P−10172
S2643
26463

PARTY'S NAME	VEER−O−METALS PVT. LTD., BANGALORE
PARTY'S DRAWING No.	210−0262−01−01 REV.A
ALLOY & TEMPER	6063 T5
DESCRIPTION	HEAT SINK SECTION

DRAWING No.	SECTION No.
P−10172	−
S2643	S2643(ISSUE−4)
26463	26463

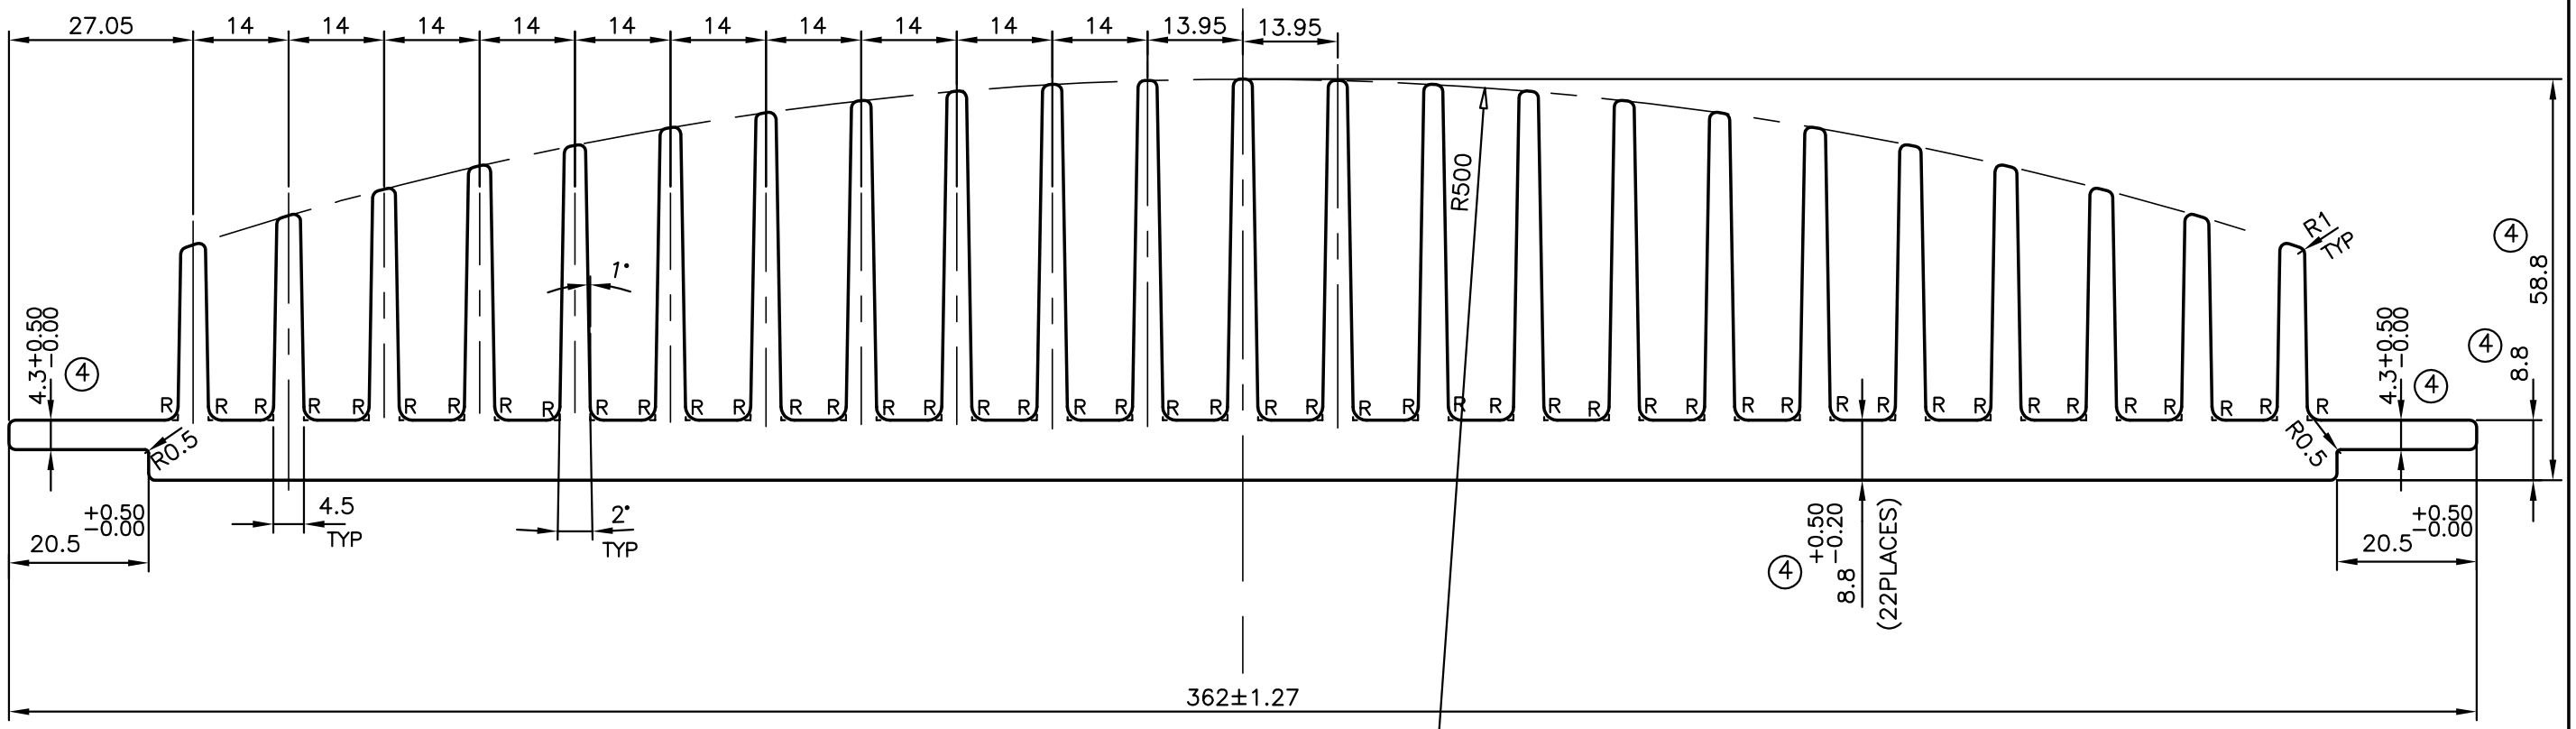
ISSUE−2 :− TOLARANCE CHANGED FROM $8^{+0.00}_{-0.70}$ TO $8^{+0.50}_{-0.20}$ & TOLERANCE ADDED ON 8 mm ±0.30

ISSUE−3 :− DIMENSIONS CHANGED FROM $8^{+0.50}_{-0.20}$ mm TO $8.5^{+0.50}_{-0.20}$ mm & 8±0.30 TO 8.5±0.30 & 58 TO 58.5 mm

WEIGHT ALSO CHANGED FROM 17.063kg/M TO 17.551kg/M

ISSUE−4 DIMENSIONS CHANGED FROM

58.50mm TO 58.80mm

8.50±0.30 TO 8.80 (2 PLACES)

$8.50^{+0.50}_{-0.20}$ TO $8.80^{+0.50}_{-0.20}$ (22 PLACES)

$4.00^{+0.50}_{-0.00}$ DIMENSION REMOVED

$4.30^{+0.50}_{-0.00}$ DIMENSION ADDED ON LEG THICKNESS (2 PLACES)

WEIGHT ALSO CHANGED FROM 17.551kg/m TO 17.789kg/m
